**FINAL INTERIM MEASURE/INTERIM
REMEDIAL ACTION FOR
THE ORIGINAL LANDFILL
(INCLUDING IHSS GROUP SW-2;
IHSS 115, ORIGINAL LANDFILL
AND IHSS 196, FILTER BACKWASH POND)**

March 10, 2005

Appendix H Comment Responsiveness Summary

Figure 3-2 Inferred Fault in Original Landfill Area

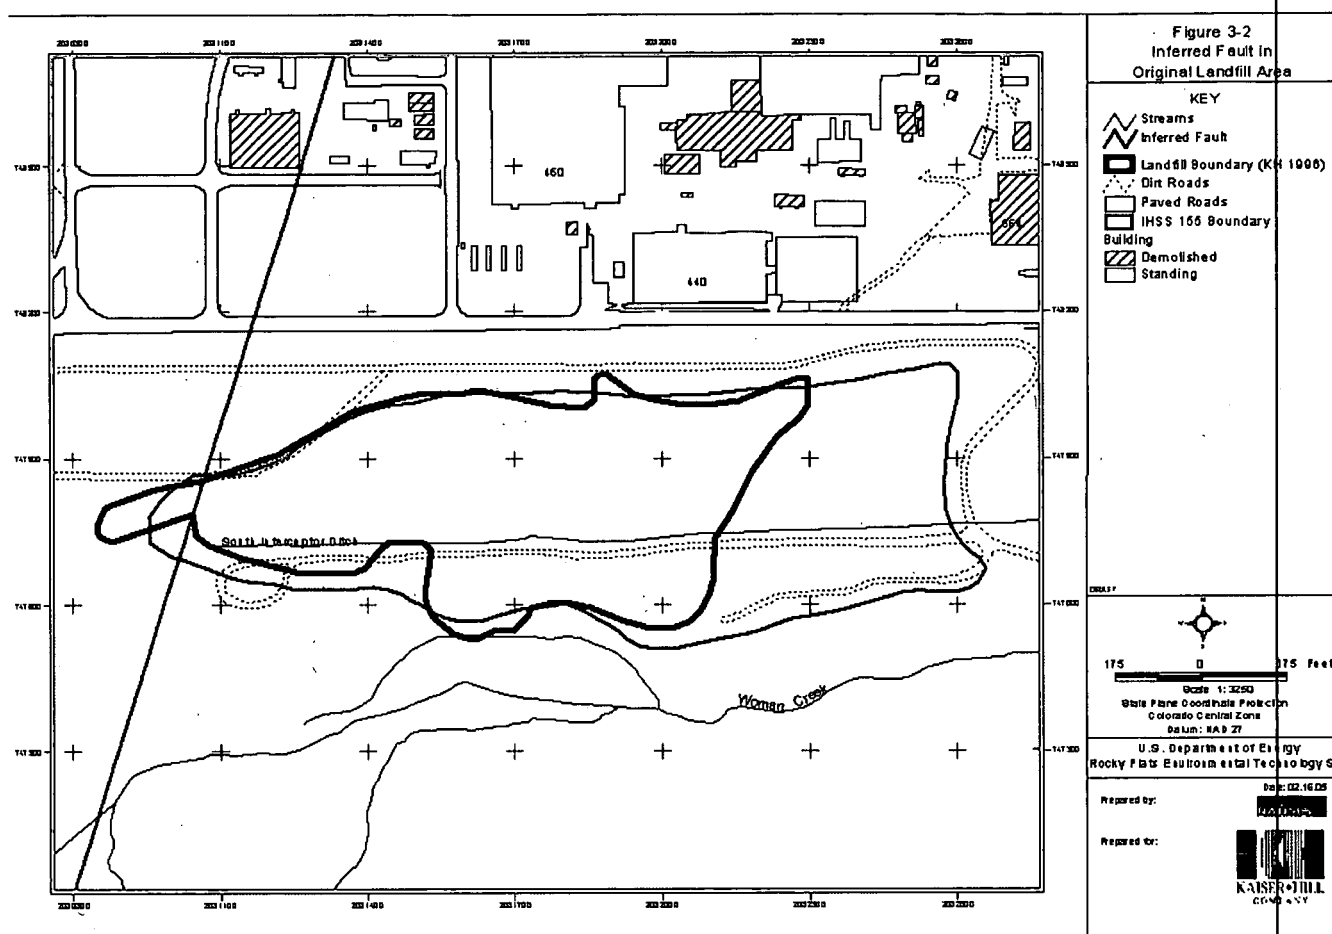
Section 3.5.5 (page 3-5)	
	The statement that "the fault is not expected to disrupt the engineering features ... and does not appear to impact groundwater hydrogeology" should be supported with evidence or references.	<p>The fault trace on Figure 3-2 is not correctly located. It's bearing is right, but it should have been located near the very western part of the waste material, nearly 600 feet west of where it was shown. If the inferred fault were a significant hydrologic feature, evidence of this would be reflected in several ways. One way would be that groundwater levels near the fault locally decrease along the lineament if it were a more permeable pathway. Conversely, if it were a less permeable feature, or a barrier to flow, groundwater levels would locally build-up behind it and drop off suddenly downgradient. Another indication the fault was a notable hydrologic feature would be an increase in vegetation density along the lineament. Finally, if a fault did exist, and it crosses Woman Creek, there would be clear evidence of localized surface discharge at the intersection of the inferred fault and the creek.</p> <p>To support the integrated flow model of the OLF system, available</p>

Figure 4-17 Dissolved Strontium-90 in Groundwater

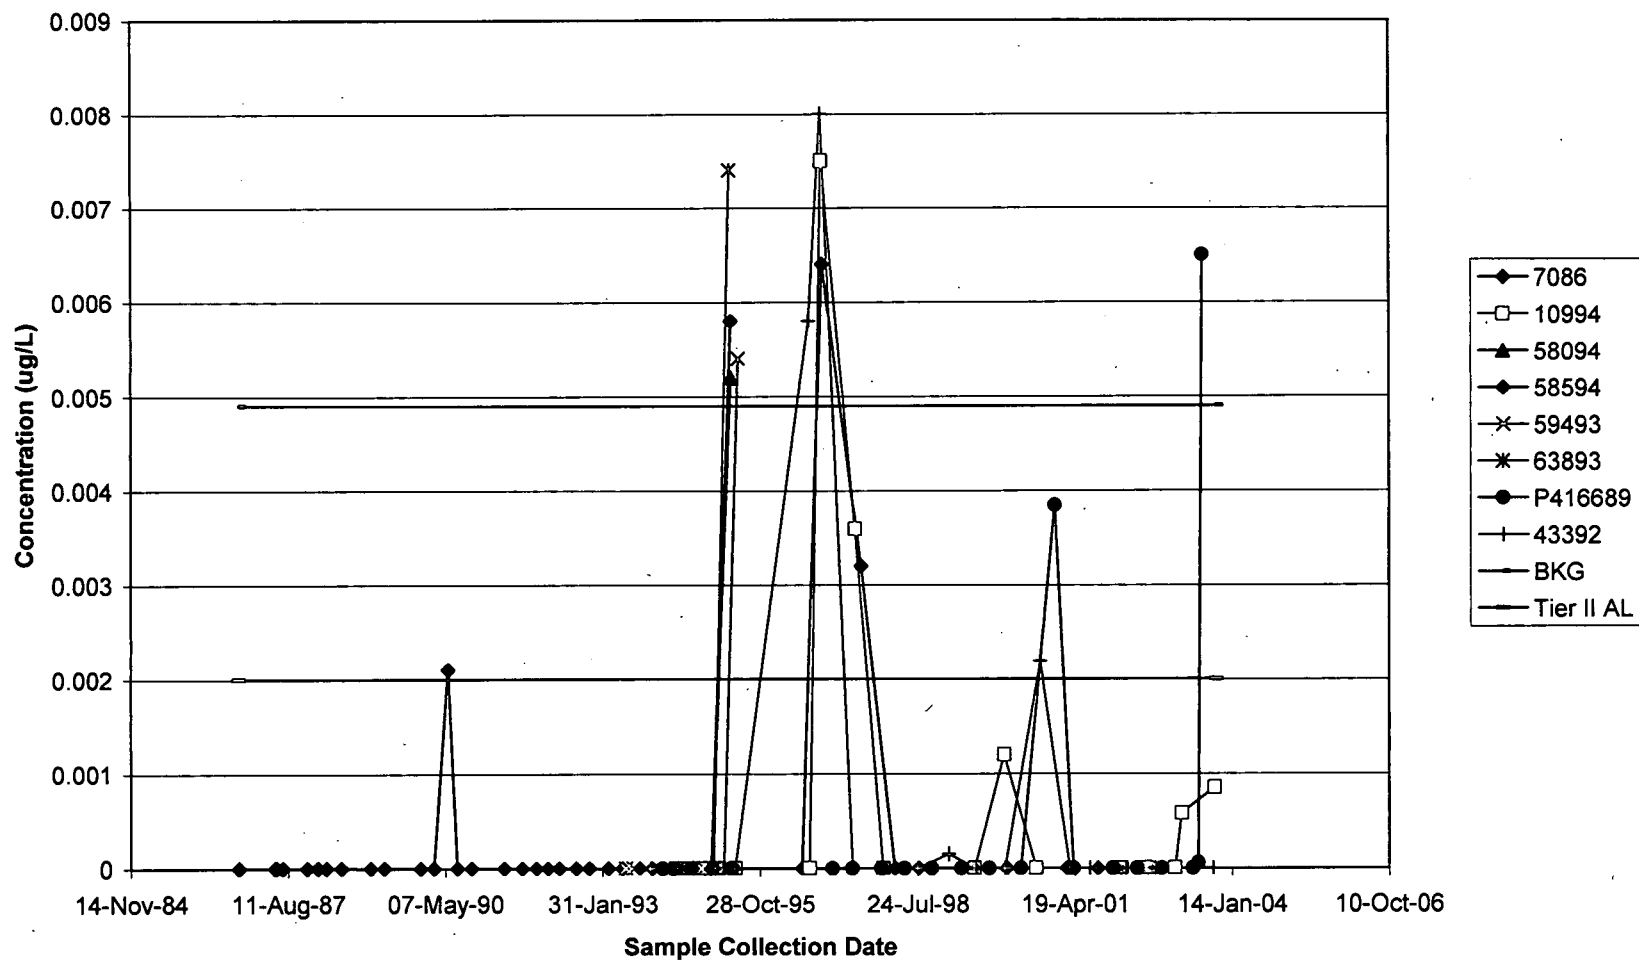
5.2		<p>Clarify the source of strontium-90 in the groundwater wells.</p>	<p>Figure 4-17 indicates that strontium-90 concentrations fluctuate around the background concentration, which indicates the strontium-90 is largely at</p>

**Figure 6.1
Conceptual Surface
Grading Plan**

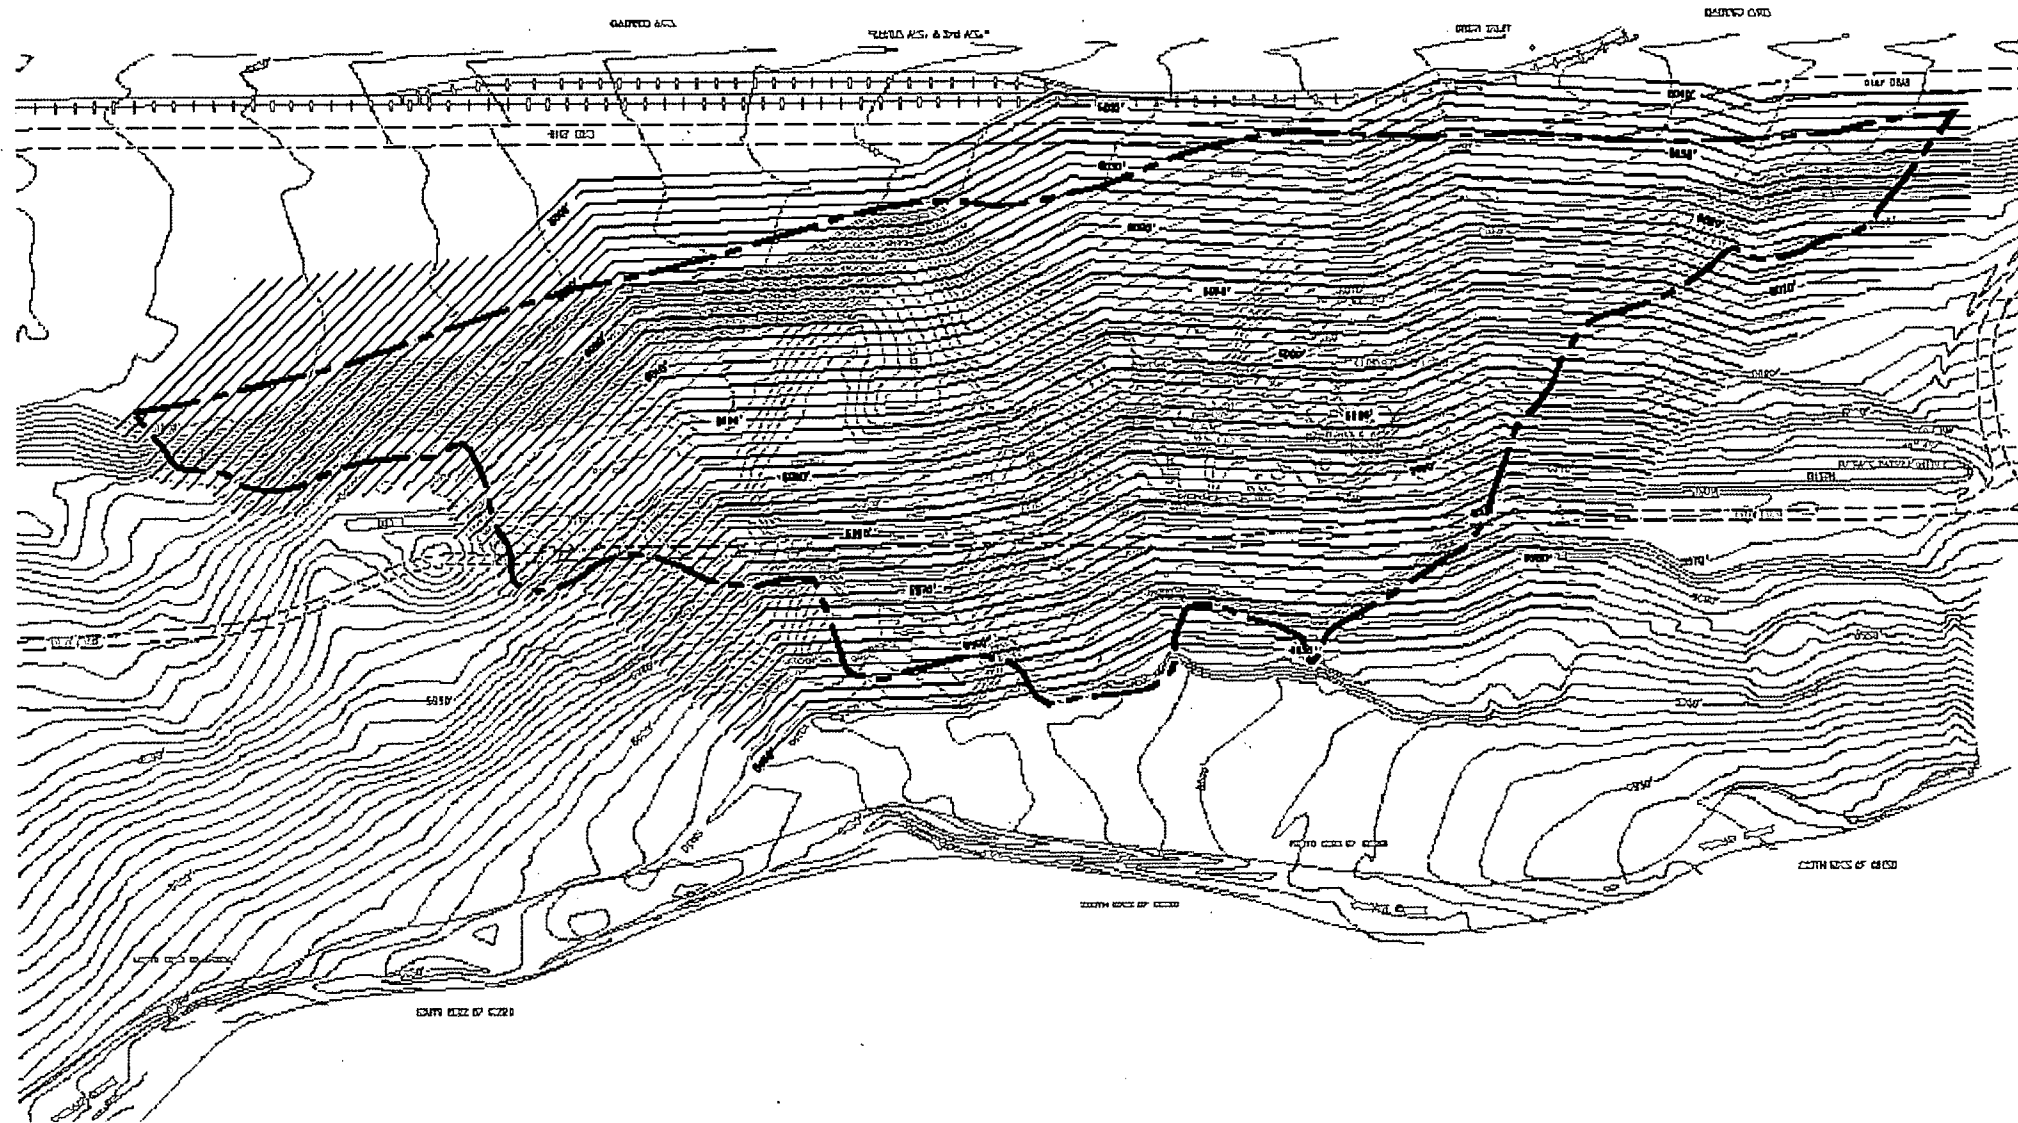
24		Figure 6.1, Conceptual Surface Grading Plan – Some of the contours do not match the adjacent contours. The grading plan should try to match the existing contours in adjacent hillsides as much as possible. It may be best to include the area east of the landfill up to the existing road to match the contours.	This figure is a conceptualization of the new cover slope. The final design will establish the final grades and will be designed to match the existing contours adjacent to the OLF.
25		Section 6.1.2, page 6-5, second paragraph – How was a thickness of 2 feet determined? Why not one foot, or three feet, or even four feet? Please describe how this depth was determined. Will there be monitoring to ensure that the minimum soil depth is retained over the long-term?	A 2-foot soil cover is commonly used for municipal landfill covers and is appropriate for the cover at the OLF since the majority of the waste material is construction debris and solid waste (trash). Two feet is the minimum required cover under current Municipal Landfill regulations governing closure of sanitary landfills. We believe this thickness to be sufficient for long-term effectiveness in preventing direct contact with landfill soil and commingled debris.
